DEPARTMENT OF TRANSPORTATION**Federal Aviation Administration****14 CFR Part 39**

[Docket No. FAA-2011-0994; Directorate Identifier 2010-NM-143-AD]

Airworthiness Directives; Bombardier, Inc. Model CL-600-2C10 (Regional Jet Series 700, 701, & 702), CL-600-2D15 (Regional Jet Series 705), and CL-600-2D24 (Regional Jet Series 900) Airplanes**AGENCY:** Federal Aviation Administration (FAA), DOT.**ACTION:** Notice of proposed rulemaking (NPRM).

Figure 1
LH side shown
RH side opposite

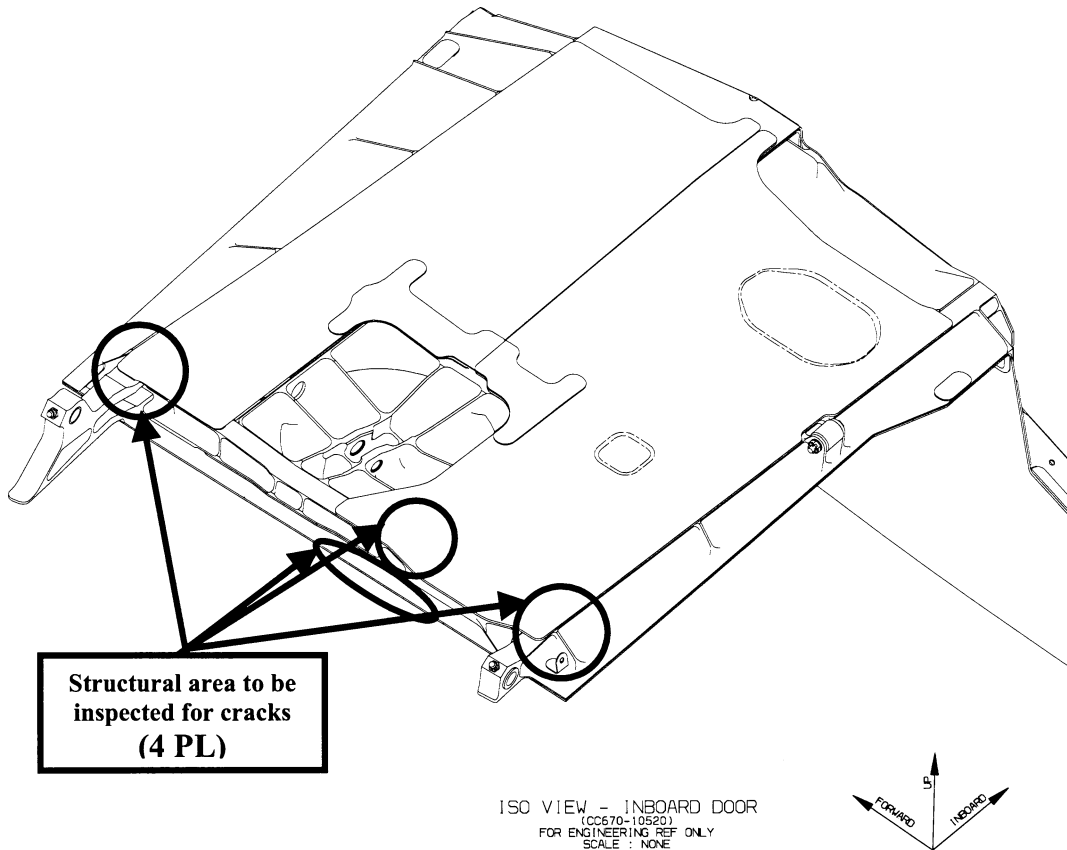
(h) For Model CL-600-2C10 (Regional Jet series 700 & 701) series airplanes, S/Ns 10003 through 10230 inclusive; and Model CL-600-2D24 (Regional Jet series 900) series airplanes, S/Ns 15002 through 15053 inclusive, 15055 and 15056: At the applicable time specified in paragraph (g) of this AD, perform detailed inspections of the lower panel, part number (P/N) CC670-10520, of the left- and right-hand MLG doors for the conditions and in the areas specified in paragraphs (h)(1), (h)(2), (h)(3), and (h)(4) of this AD; and Figures 1, 2, and 3 of this AD.

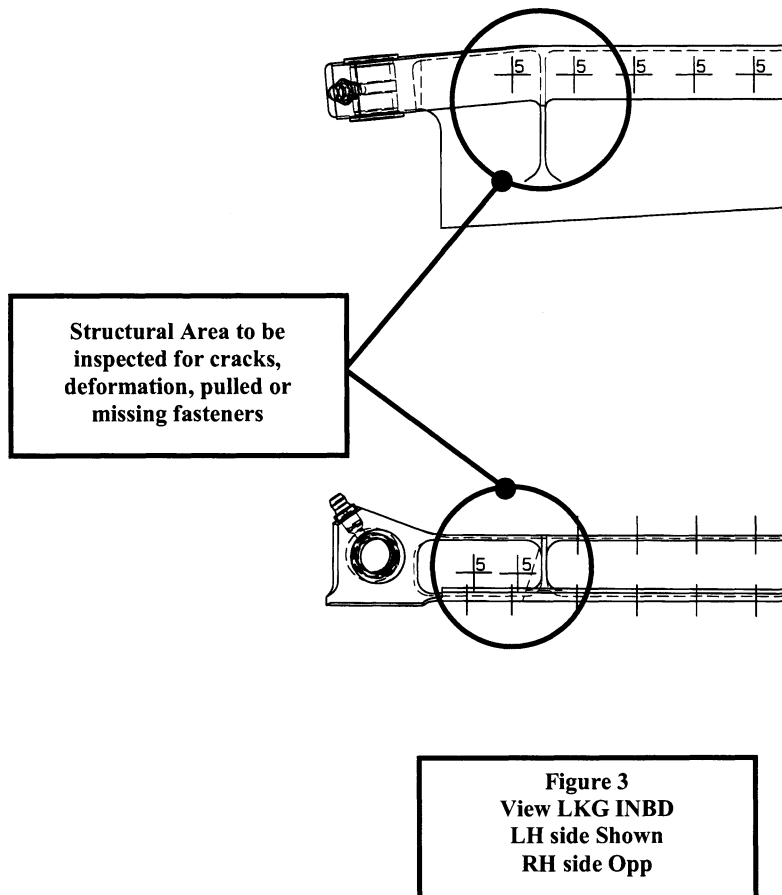
(1) Inspect the cross member, P/N CC670-10572, of the MLG door lower panel for cracking or deformation, in accordance with Figure 2 of this AD.

(2) Inspect the inner skin, P/N CC670-10577, of the MLG door lower panel at the cross member (P/N CC670-10572) for cracking or deformation, or pulled or missing fasteners, in accordance with Figure 2 of this AD.

(3) Inspect the outer skin, P/N CC670-10574, of the MLG door lower panel at the cross member (P/N CC670-10572) for cracking or deformation, or pulled or missing fasteners, in accordance with Figure 2 of this AD.

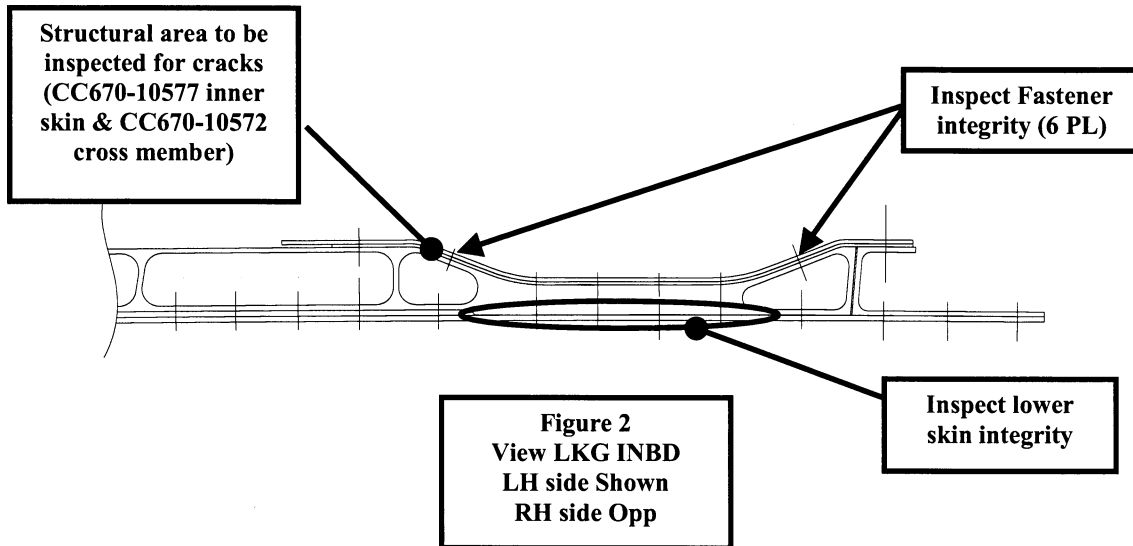
(4) Inspect the forward member, P/N CC670-10570, and aft member, P/N CC670-10571, of the MLG door lower panel for cracking or deformation, or pulled or missing fasteners, in accordance with Figure 3 of this AD. Figures 1 through 3 of this AD follow.
